# FCPS Rock Creek School

## Replacement and Final Site Selection

### Design Meeting #7 - Notes

**Current Design Phase:** Schematic Design

Attachments: Building Adjacency sketch

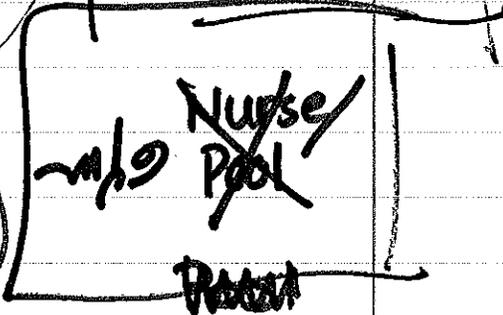
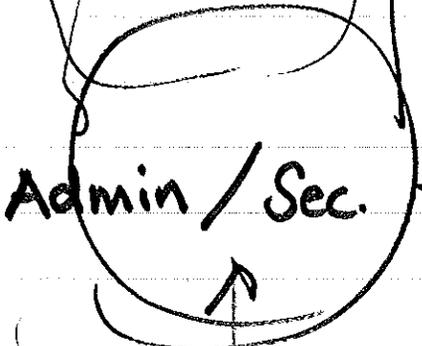
7. Mary and Meghan presented a sketch they had prepared with their ideal adjacencies. There is a desire to separate shared functions (gym, pool, cafeteria, media) to encourage movement. See attached. This will be used as the basis for the bubble diagrams with some notes/updates made to the sketch during the meeting:

- Gym and pool flipped to pull gym closer to front entrance, fields, and parking.
  - The Nurse/Health area should be close to the main office, but does not need to be directly adjacent since there is nursing staff available full time. Health area should have an exterior door to allow for ambulance access.

- Placement of the greenhouse will need to be considered to optimize southern exposure.
  - There was some discussion about mirroring portions of the plan or shifting the classroom cluster locations due to adjacencies or site layout. This will be reviewed as diagrams progress.
